9/13/96	Class B Concrete changed to Class A.
6/14/96	Notes added to clarify plans.
DATE	REVISION
STATE OF HAWAII DEPARTMENT OF TRANSPORTATION HIGHWAYS DIVISION	
DRAINAGE PLAN	
KALANIANA'OLE HIGHWAY RESURFACING	
Kailua Rd. to Hilo St.	
Project No. 72A-01-96M	
Scale: 1"=40'	Date: May 1996
SHEET No. 44 OF 44 SHEETS

KALANIANA'OLE HIGHWAY RESURFACING

Project No. 72A-01-96M

2'x1' CONCRETE LINED VEE DITCH

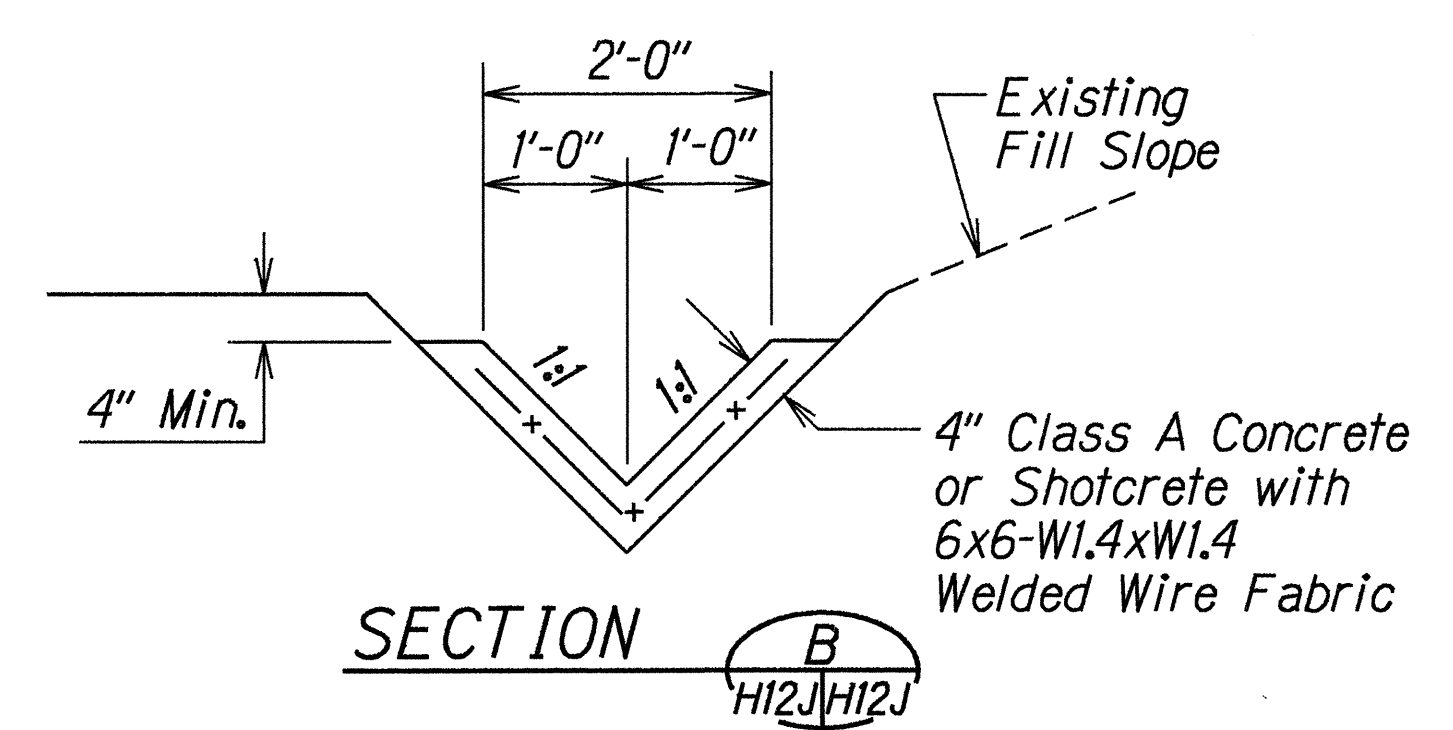
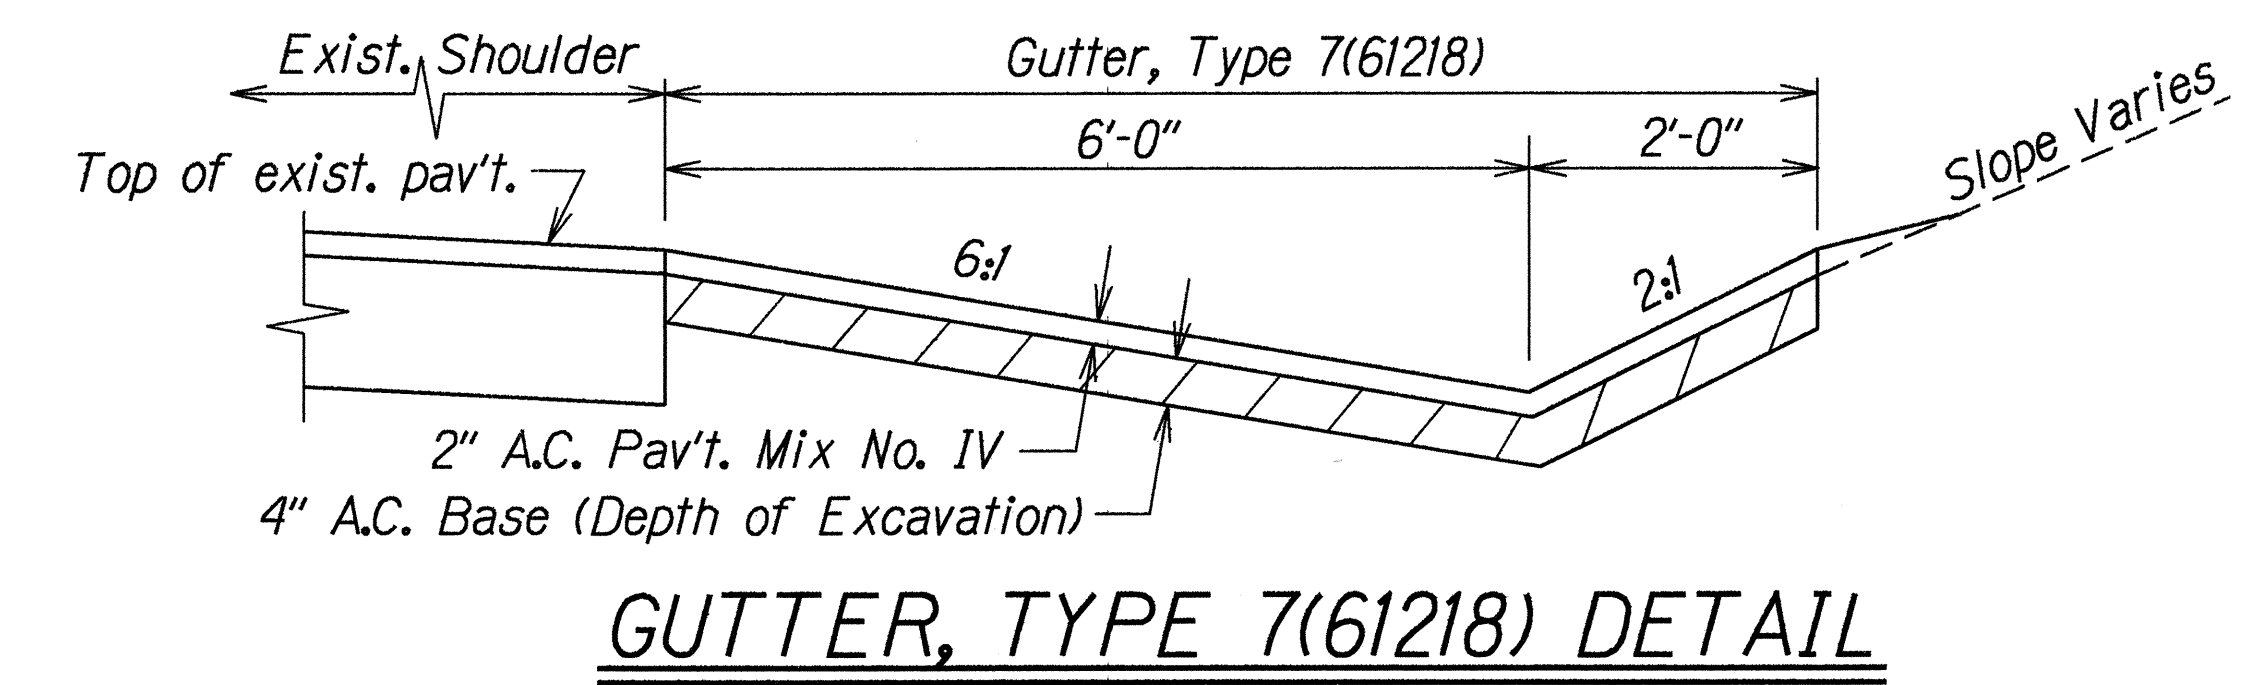
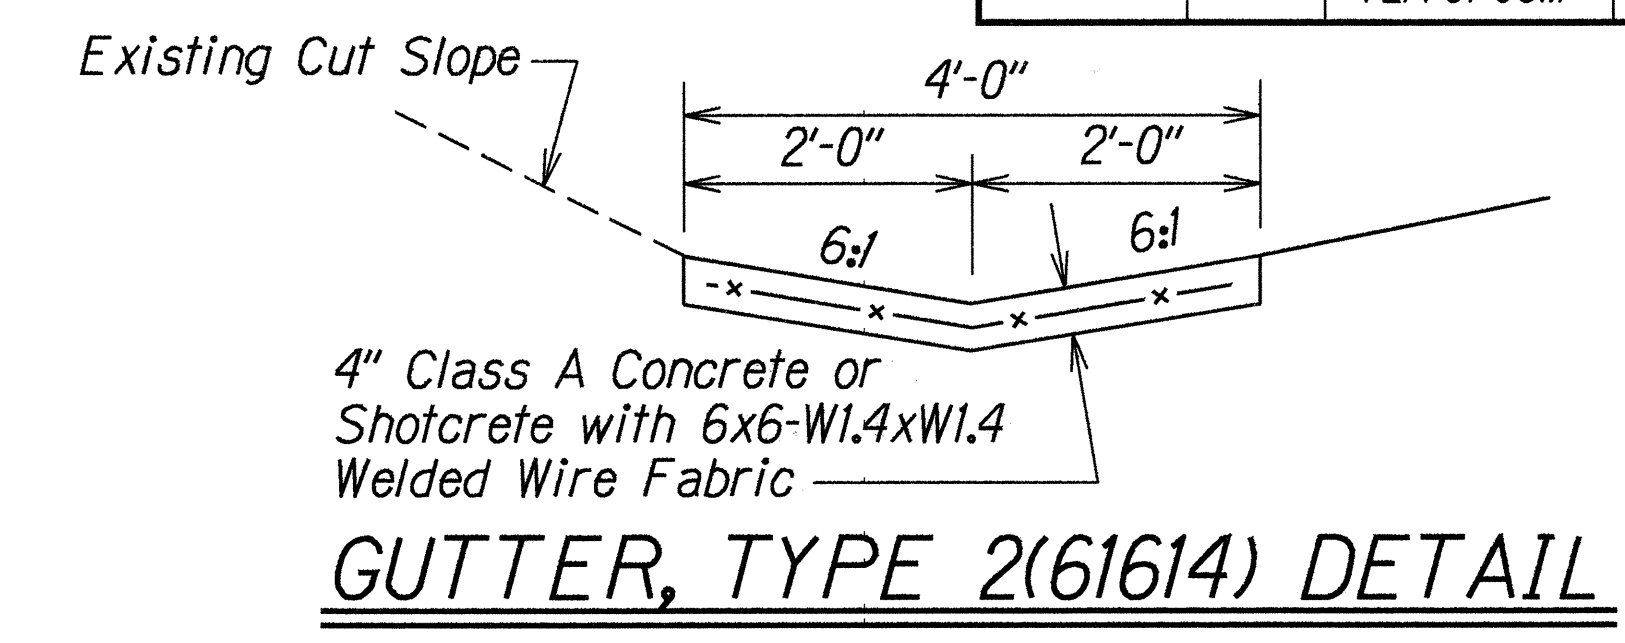
9/13/96	Class B Concrete changed to Class A.
6/14/96	Details added to complete drainage plan.
DATE	REVISION
STATE OF HAWAII DEPARTMENT OF TRANSPORTATION HIGHWAYS DIVISION	
DRAINAGE DETAILS	
KALANIANA'OLE HIGHWAY RESURFACING	
Kailua Rd. to Hilo St.	
Project No. 72A-01-96M	
Scale: 3/4"=1'-0"	Date: May 1996
SHEET No. H12J OF 12 SHEETS
